Summary of Evidence for PC7 Hearing

Helen Rutter for DairyNZ

Evidence for nitrate transfer pathway at depth

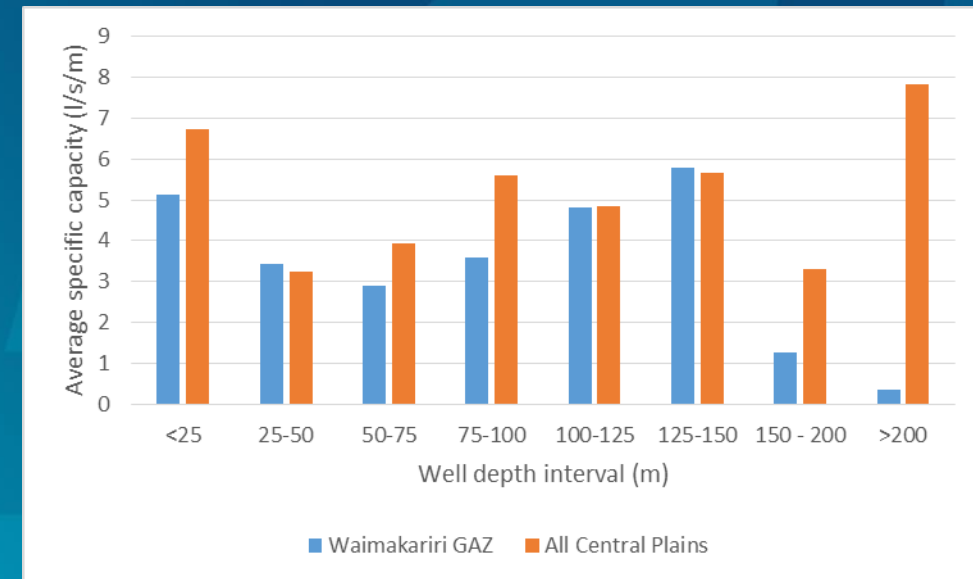
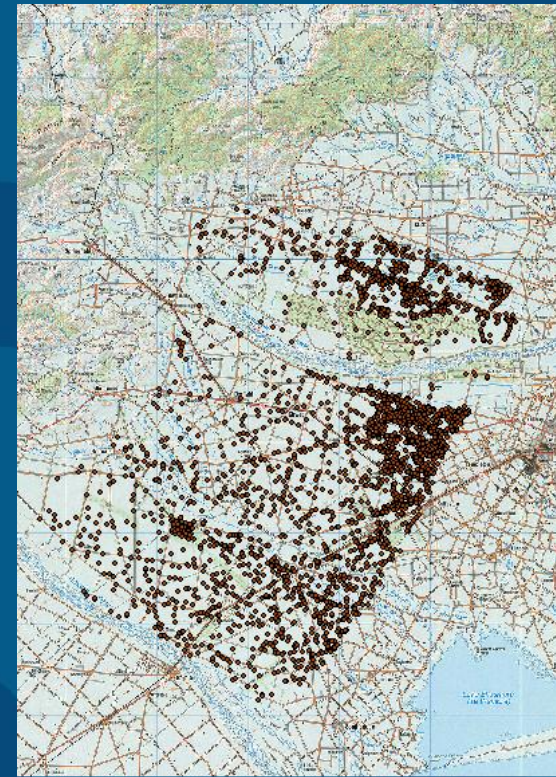
- Specific capacity of wells used to indicate permeability and hence opportunity for deep nitrate transfer pathway
- Assessment by ECan was carried out on wells across the Selwyn-Waihora and Christchurch-West Melton GAZs as well as the Waimakariri GAZ
 - Suggested high permeability at depths > 200m
- No evidence for this in data for the Waimakariri GAZ

Existing groundwater quality at depth

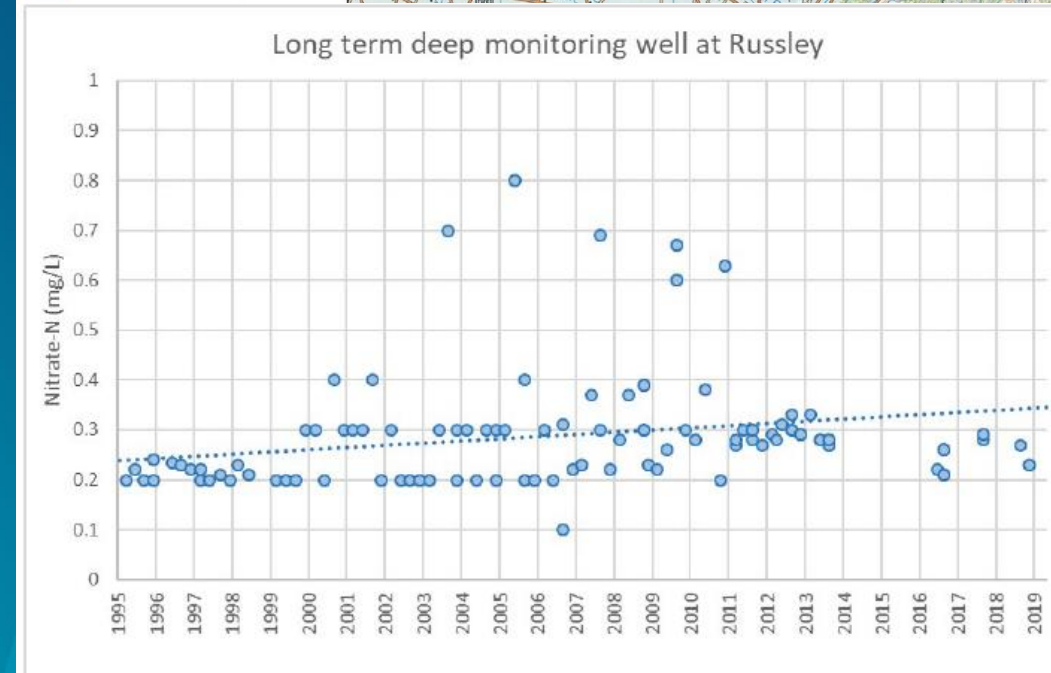
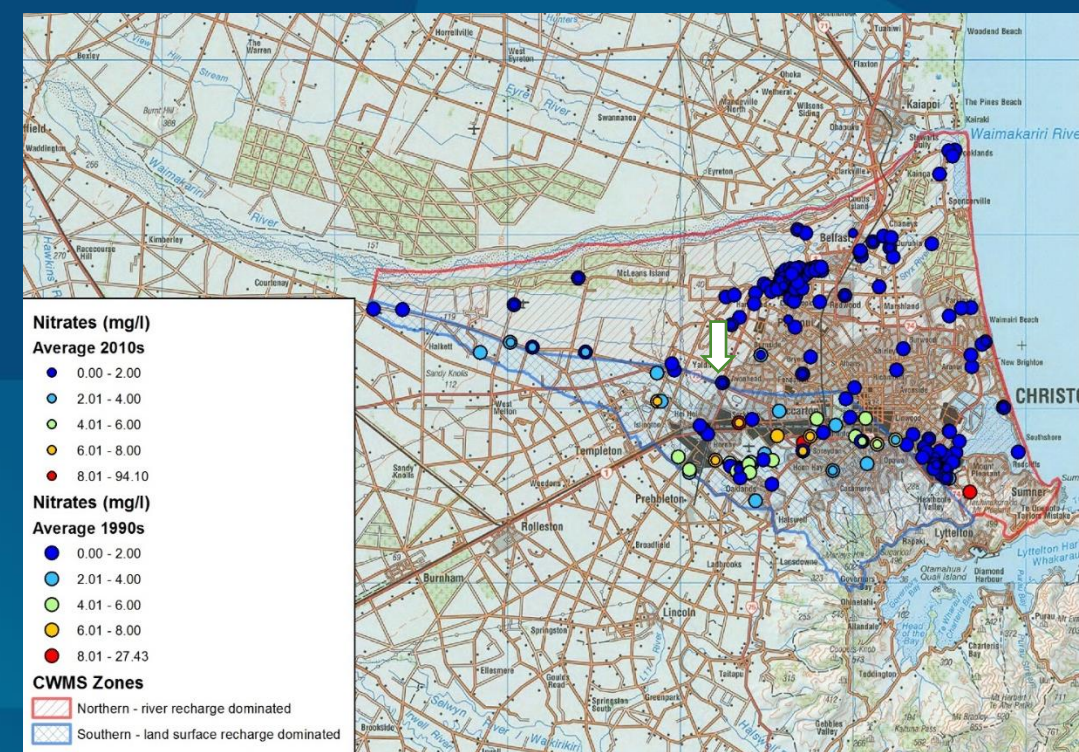
- Russley bores
 - M35/6791 188-200m
 - M35/6040 170-176m
- Data used to show evidence of increasing (but very low) nitrates at depth
 - Possibly due to land surface recharge south of the Waimakariri river

Existing groundwater quality at depth

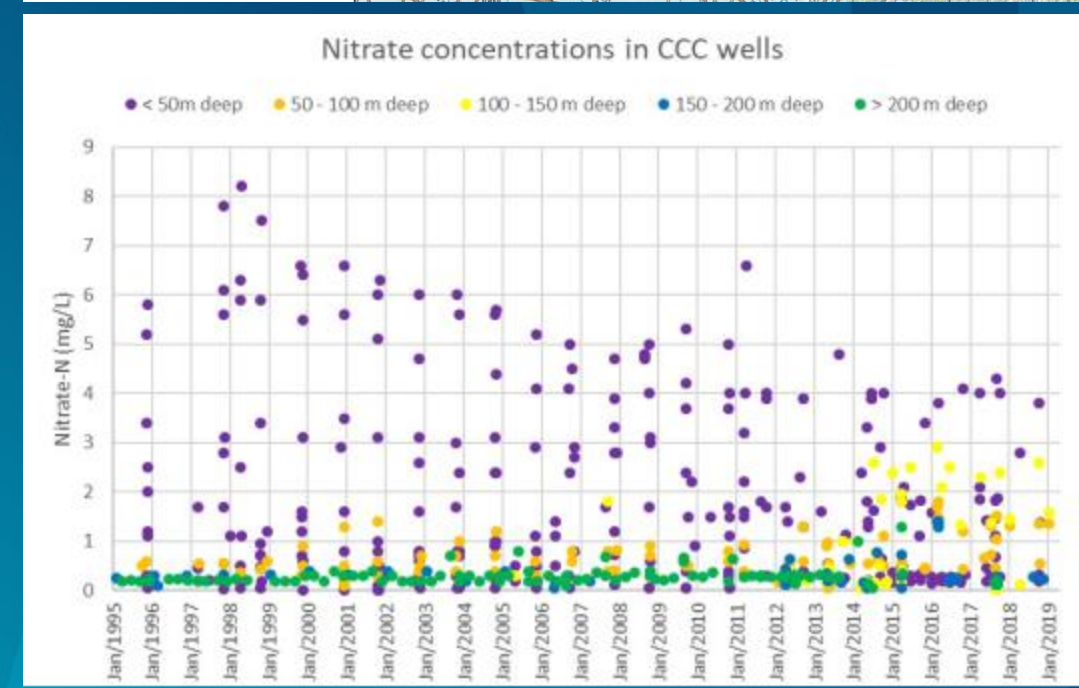
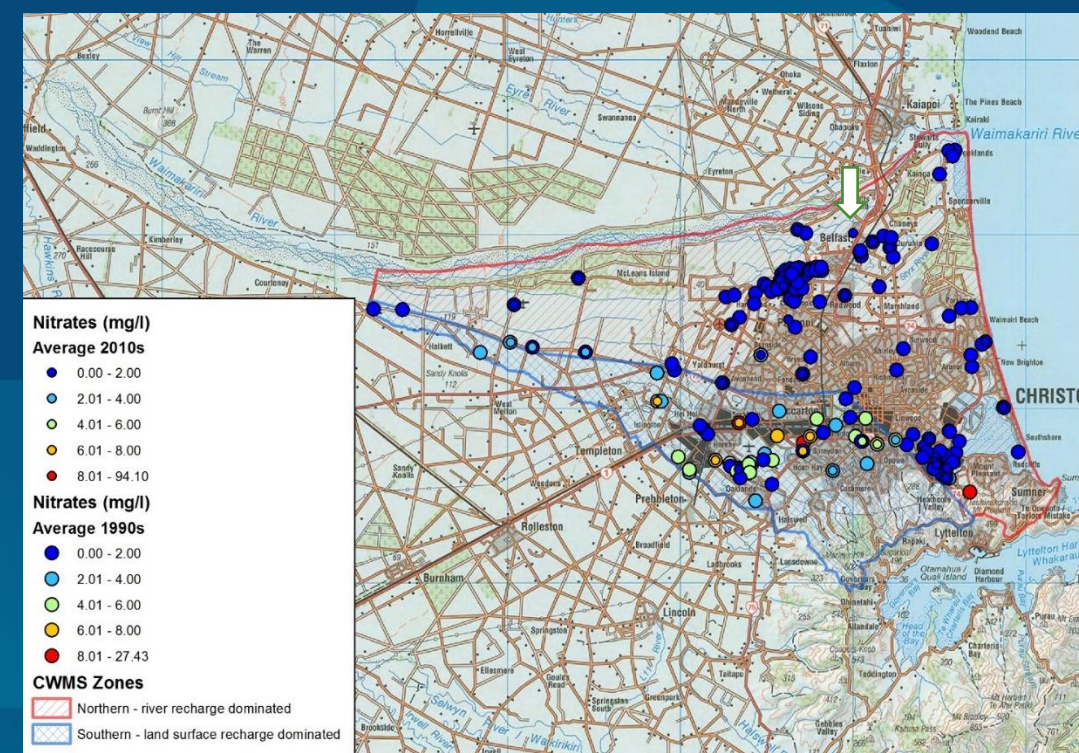
- Increase in nitrate-N concentrations at > 100m depth based on one well in Belfast (M35/10632)
- There appears to be limited other evidence for an increasing trend in nitrates under Christchurch, other than in shallower wells (screened less than 40m depth) in the southwest of the city

Differences between measured concentrations and model predictions

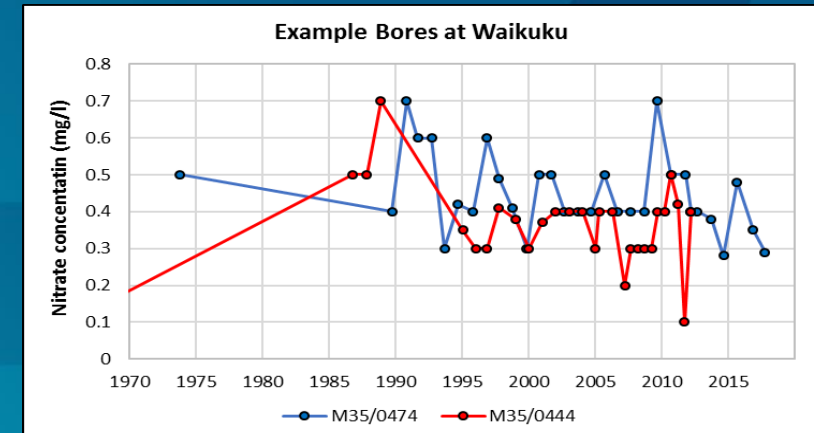
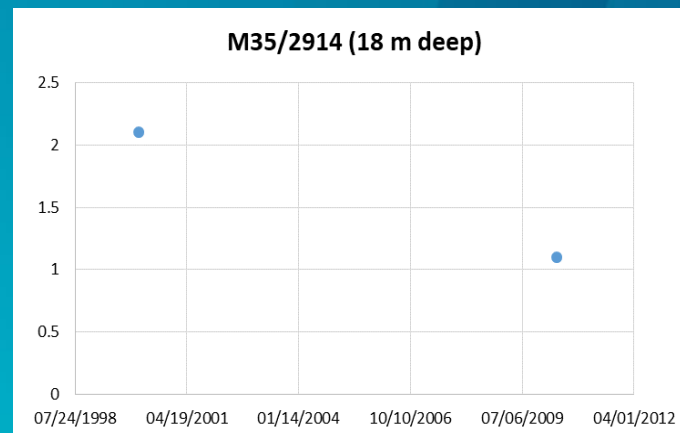
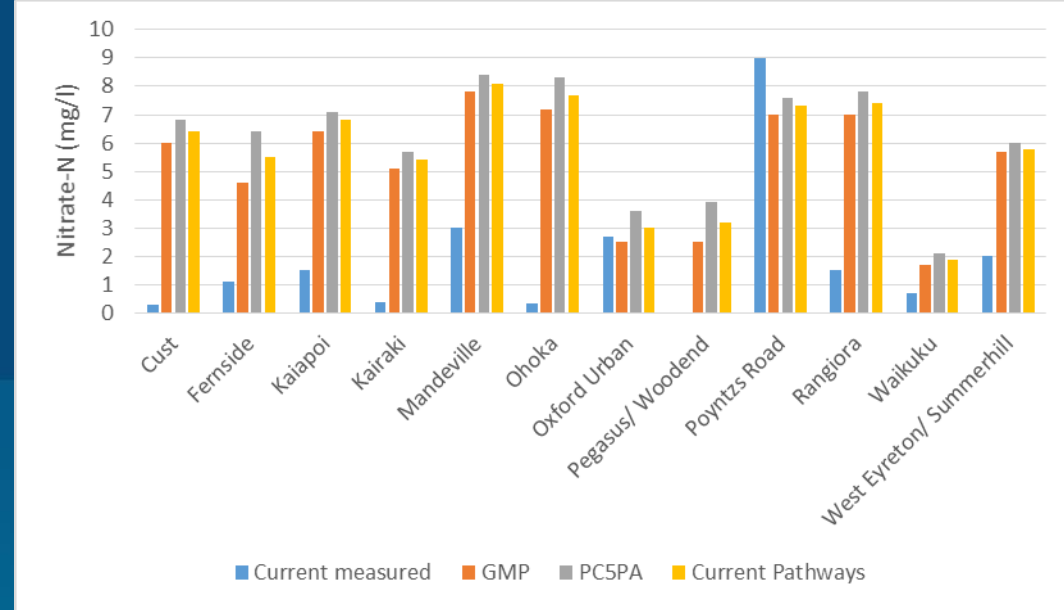
- Can't expect model to match measured exactly
 - Uncertainty in inputs
 - Need to account for the lag time
- However, considerable disparity between modelled nitrate concentrations at WDC and private water supply areas, relative to modelled concentrations
